October 15, 1984
ST-HL-AE-1140
File Number: G12.116

South Texas Project
Units 1 & 2
Docket Nos. STN 50-498, STN 50-499
Revised Final Report Concerning the Design
of the Residual Heat Removal System

FIGURE 1

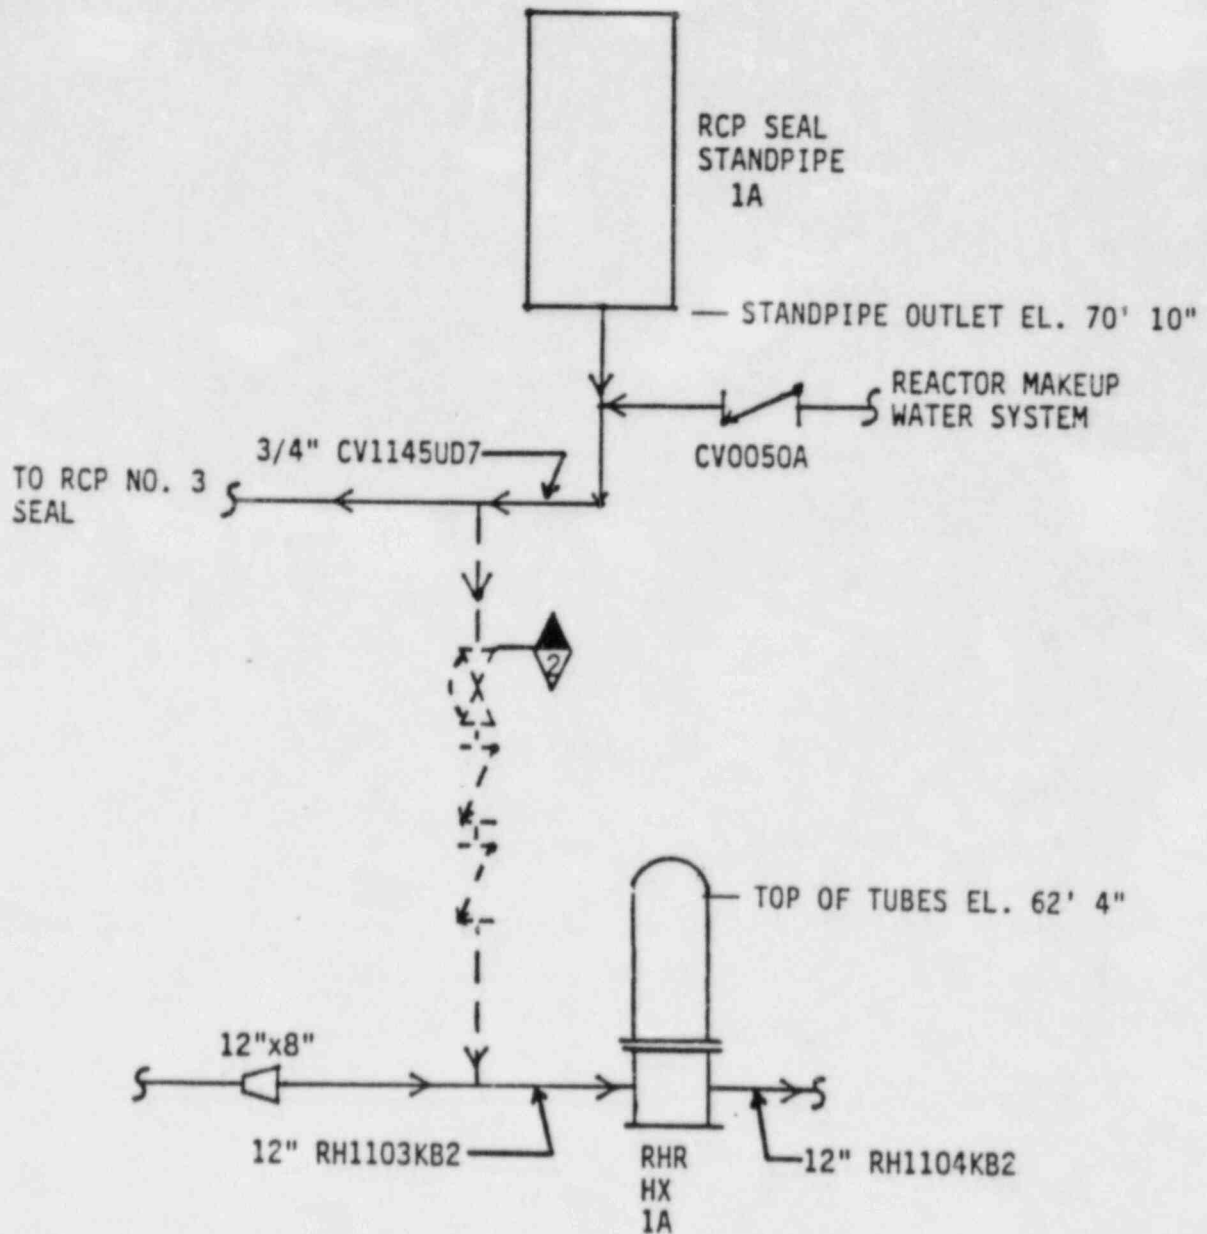
The head tank system will utilize existing Reactor Coolant Pump (RCP) No. 3 Seal Standpipes A, B and C as head tanks to maintain a positive static head on the RHR system and keep the RHR heat exchanger tubes filled. Each RHR train will utilize the corresponding reactor coolant loop's standpipe. A line will be routed from each of the RCP No. 3 Seal Standpipes to the inlet of the RHR heat exchangers. Makeup to the Seal Standpipe will be from the Reactor Makeup Water System. The system is not required for safe shutdown nor is it required to insure the integrity of the Reactor Coolant Pressure Boundary.

A schematic representation of the revised design is shown in figure 1. A description of this system will be provided in the FSAR.
